Addendum No. 3 to IFB 18-24

To: All Parties on Record with the City of Somerville as Holding IFB 18-24, **Somerville Avenue Utility and Streetscape Improvements**

Re: Answer Late Questions Resulting in Revisions to Technical Specifications

City of Somerville
Somerville Avenue Utility and Streetscape Improvements Project
IFB# 18-24

Attachment 1 – Sketch SK-L-95-1

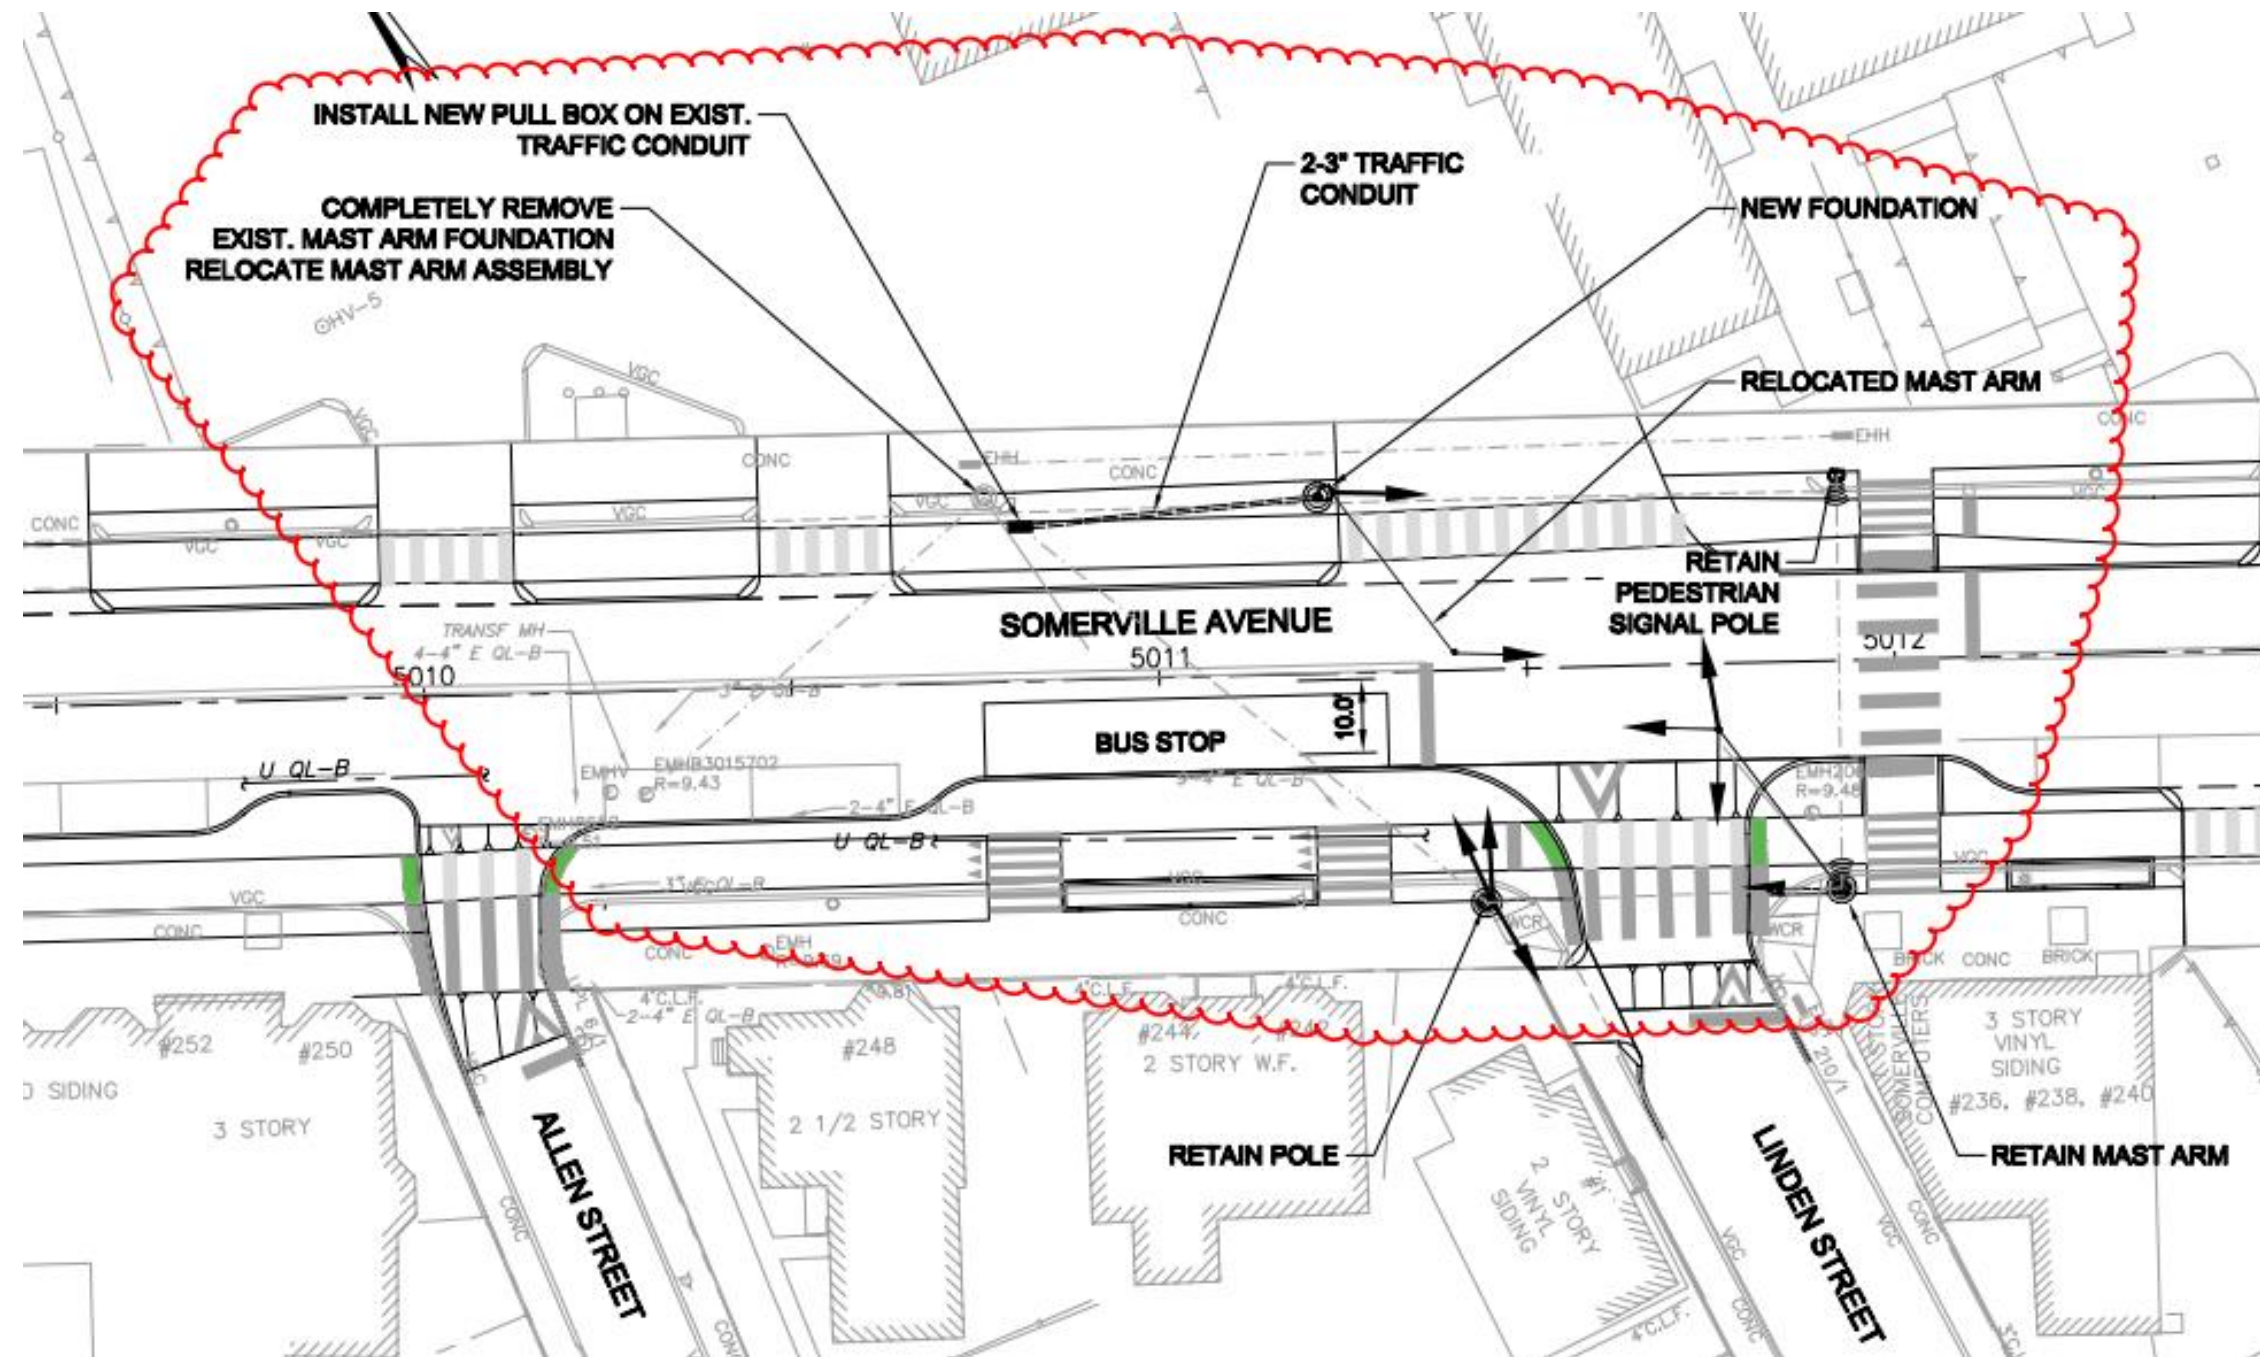
- Q2: Drawings L-90, L-93, L-95, and L-96 show the final arrangement of traffic signal work and conduit routing. Where double lines are shown on these Sheets, are there two separate conduits or one being depicted? If so, what are the sizes of the conduits to be restored??

- A2: The double lines indicate two 3” non-metallic conduits. Please also refer to Addendum No. 3, Item 5 for revisions to Sheet L-95.
- Q3: The TM drawings as pertaining to traffic signals show temporary conduits as a single conduit. What is the size of the conduit and will it need to be encased under roadways in a temporary arrangement?

5. **Drawings – Sheet L-95**

ADD new traffic control conduit and pull box, as indicated in SK-L-95-1, included as Attachment 1 to this Addendum No. 3.
